Development Management Sub Committee

**Application for Planning Permission 17/03186/FUL
At Edinburgh Airport Police Station, Almond Road,
Edinburgh Airport
Erection of a six storey hotel (Class 7), with associated
facilities, car parking and hard and soft landscaping (as
amended).**

Item number	4.1
Report number	
Wards	B01 - Almond

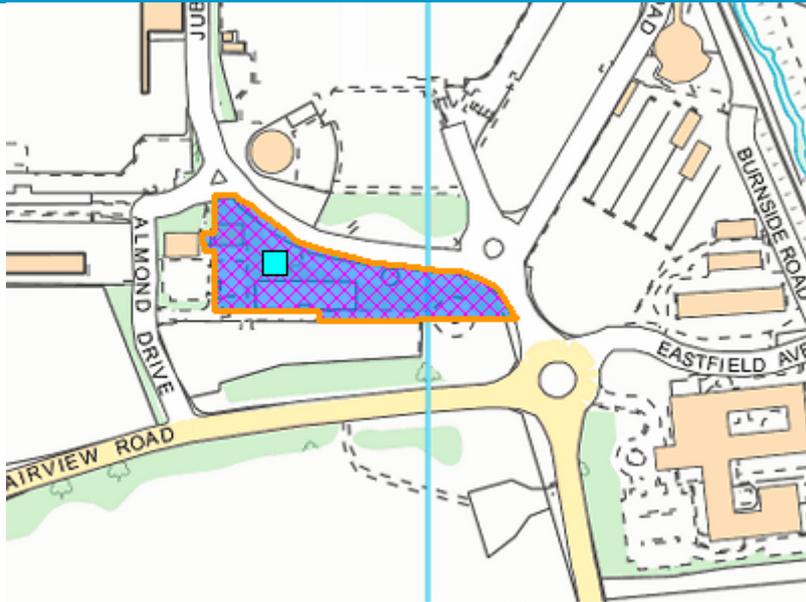
The Scottish Government in the 'Government's Programme for Scotland 2017-18 has a new ambition on ultra-low emission vehicles, including electric cars and vans, with a target to phase out the need for petrol and diesel vehicles by 2032. This is underpinned by a range of actions to expand the charging network, support innovative approaches and encourage the public sector to lead the way, with developers incorporating charging points in new developments. Therefore, the commitment of installing a rapid charger of the following standard is welcomed and shall be recommended as a condition;

70 or 50kW (100 Amp) DC with 43kW (63 Amp) AC unit. DC charge delivered via both JEVS G105 and 62196-3 sockets, the AC supply by a 62196-2 socket. Must have the ability to be de-rated to supply 25kW to any two of the three outlets simultaneously.

Prior to the use being taken up, a rapid electric vehicle charging point, capable of 70 - 50kW (100 Amp) DC with 43kW (63 Amp) AC output as show on drawing no. L (90)02 REV D dated 21 September 2017 shall be implemented.
